SERVICE BULLETIN

SUBJECT: HORIZONTAL STABILISER TRIM TABS IMPROVED DURABILITY OF CONTROL SYSTEM (MODIFICATION N398)

FIGURE I

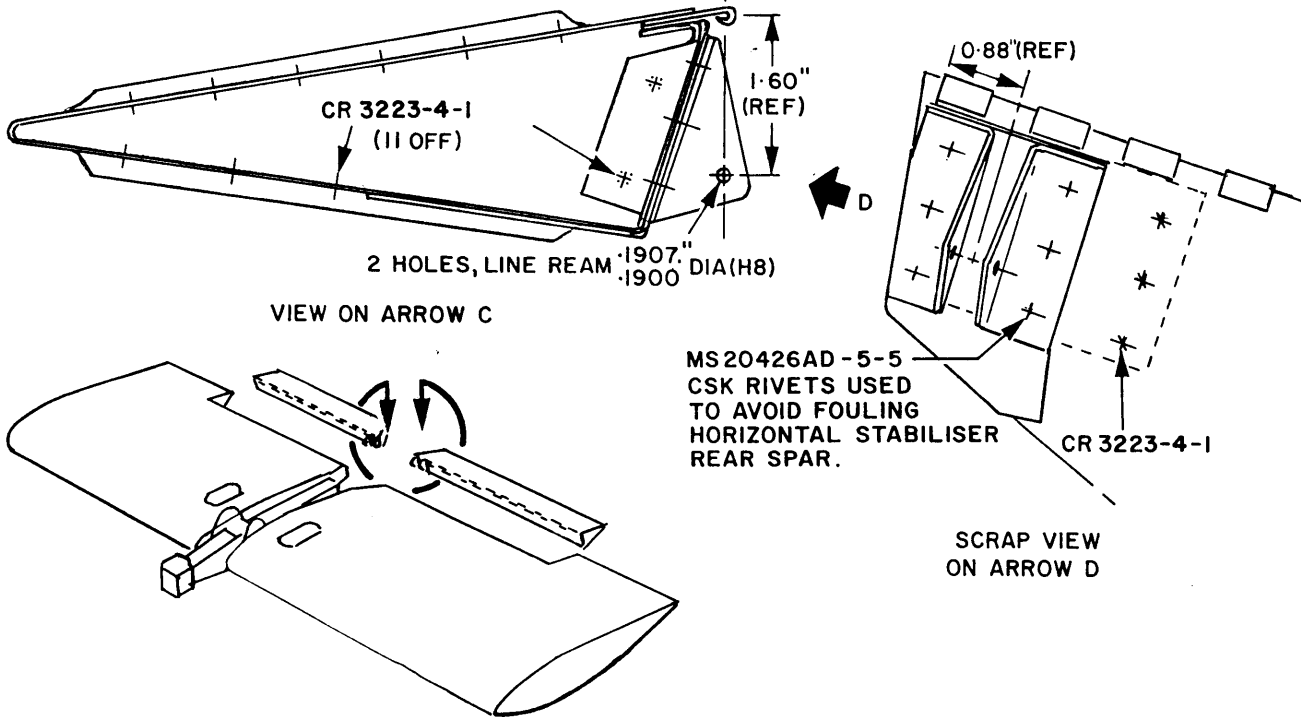
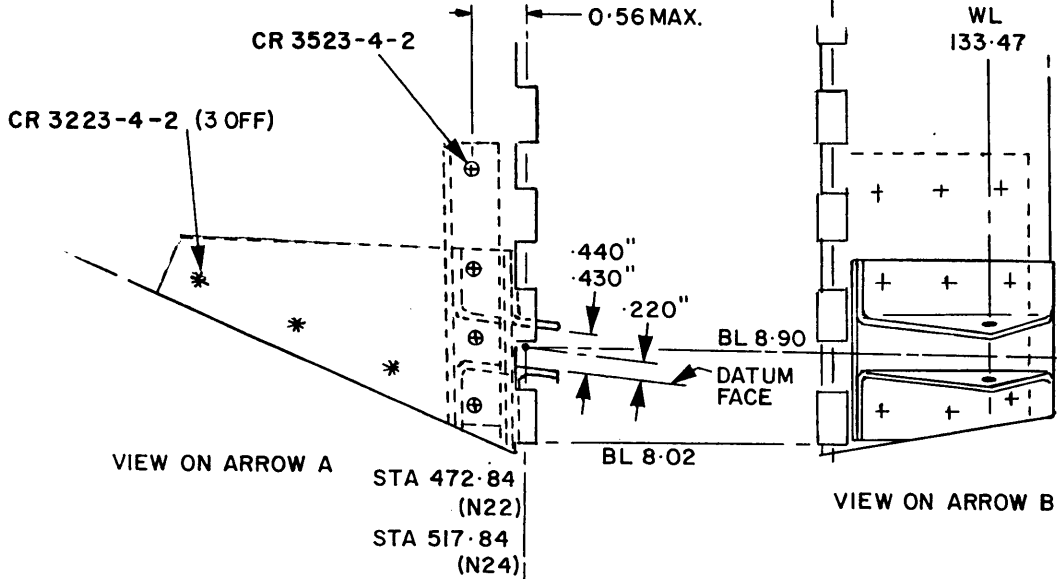
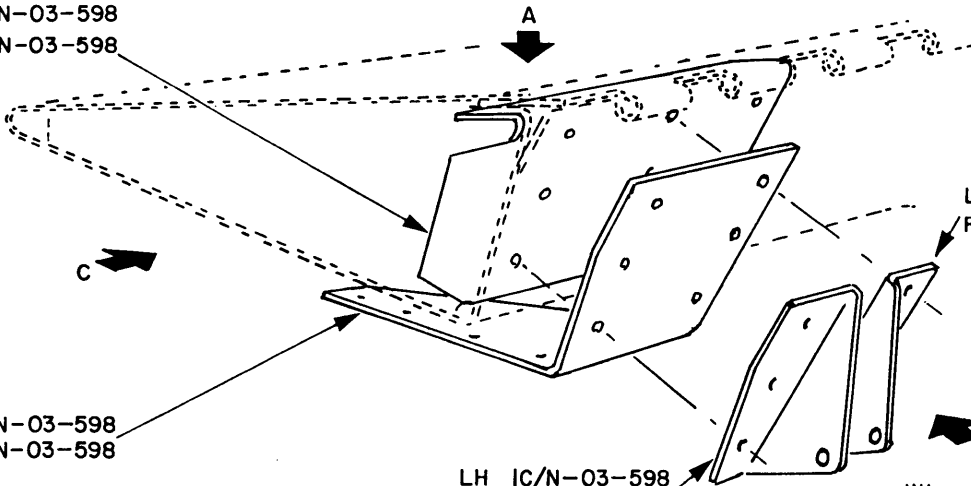
- (3) Install the modified doubler P/N IG/N-03-598 picking up the existing rivet locations through the hinge and the three (3) rivet holes through the tab web (Ref Figure 1 - view on arrow B).

- (4) Locate the external doubler P/N 1A/N-03-598 and the tab control rod attachment brackets P/N 1C/N-03-598 and 1E/N-03-598 to the LH tab.
- (5) Install the tab assembly in the rework jig P/N 1630-1620. Locate and permanently attach the control rod attachment brackets using six (6) MS20426AD-5-5 solid rivets as detailed in Figure 1.

- (6) Back drill the three holes in the tab lower surface through the new external doubler P/N 1A/N-03-598.
- (7) Refit the trim tab end rib using rivets as detailed in Figure 1.

- (8) Drill and ream the control rod attachment bracket using the trim tab rework jig P/N 1630-1620 fittings to obtain correct alignment.
- (9) Carry out the rework procedure (steps 1 to 8) on the RH trim tab using the applicable doublers and control rod attachment brackets as detailed in Figure 1.

FIGURE 2

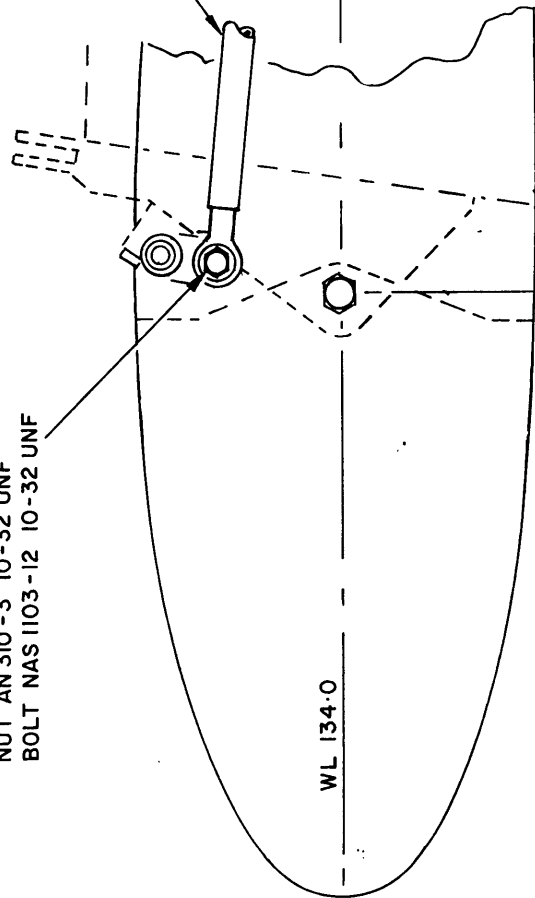
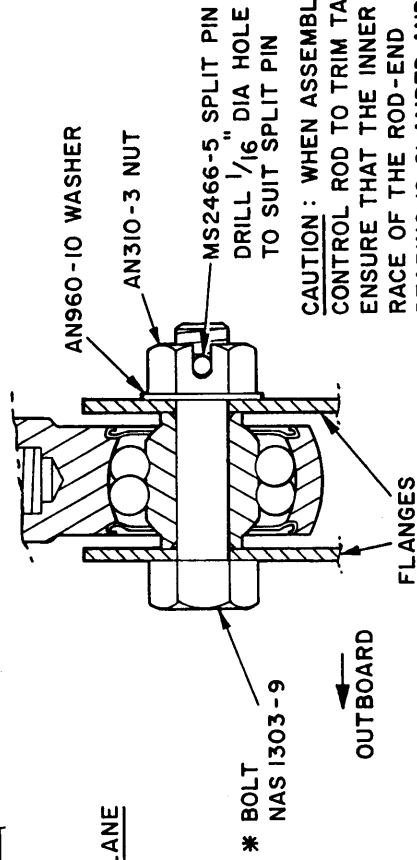
- (1) Refit the modified horizontal stabiliser trim tabs (Ref MM 55-20-00 Maintenance Practices) and the replacement tab control rods P/N 1/N-03-603 (Ref Figure 2 and MM 27-41-04 Maintenance Practices).

* BOLT HEAD TO BE ON OUTBOARD
 FACE. CHECK FOR CLEARANCE
 OF BOLT THROUGH TAILPLANE
 REAR SPAR. RELIEVE SPAR
 CUT-OUT. DETAIL A FIG.2 OF
 MOD.N407B NMD-55-10 REFERS

WHEN TORQUE TIGHTENING BOLT NUTS, OBSERVE
 TORQUE REQUIRED TO OVERCOME LOCKING INSERT
 (IF FITTED) AND ADD THIS TORQUE TO TORQUE
 TIGHTENING RANGE 20 - 25 LB IN.

CAUTION : WHEN ASSEMBLING
 CONTROL ROD TO TRIM TAB
 ENSURE THAT THE INNER
 RACE OF THE ROD-END
 BEARING IS CLAMPED AND
 THAT THE BOLT IS NOT
 SHANK BOUND.

FIGURE 3

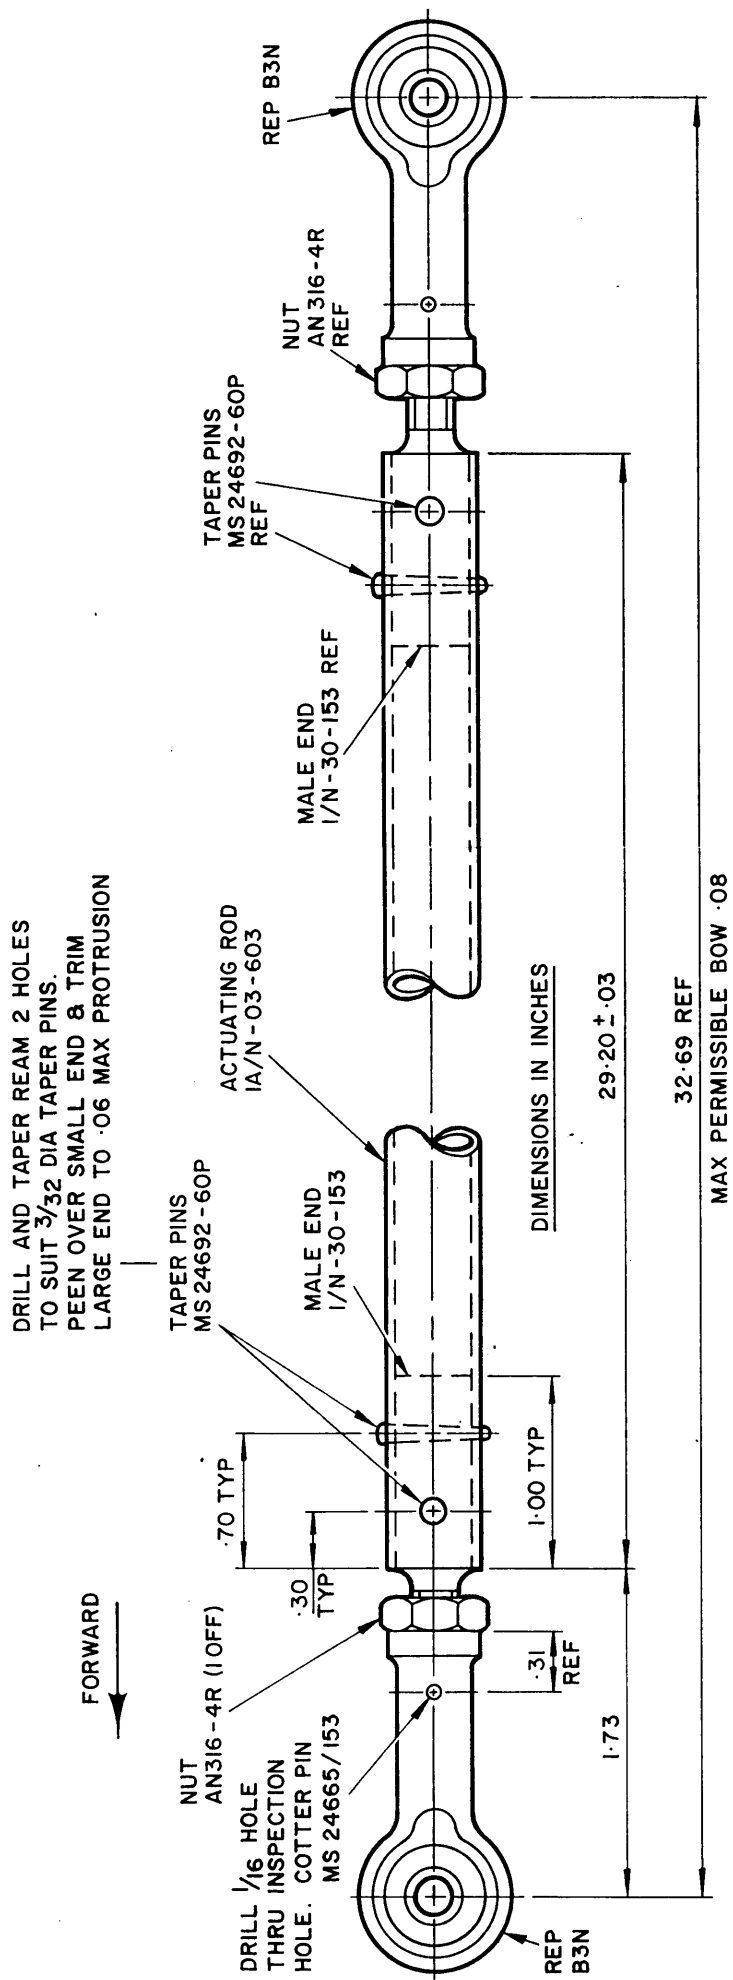
- (2) Reduce the length of control rod to $29.20 \pm .030$ inches.
- (3) Measure internal diameter of rod (0.402 inches nominal) and reduce the male end fitting 1/N-30-153 to give a clearance fit of -0.000 to + 0.002 inches.
- (4) Wet assemble control rod and male end fitting using barium chromate pigmented jointing compound or equivalent. Retain end fitting using taper pins (Ref. Figure 3).
- (5) Assemble rod end bearings P/N REP B3N. Lock forward rod end bearing by tightening jam nut and installing 1/16 inch cotter pin (Ref. Figure 3).

NOTE -- (WET ASSEMBLY WITH PIGMENTED JOINTING COMPOUND) (BARIUM CHROMATE)
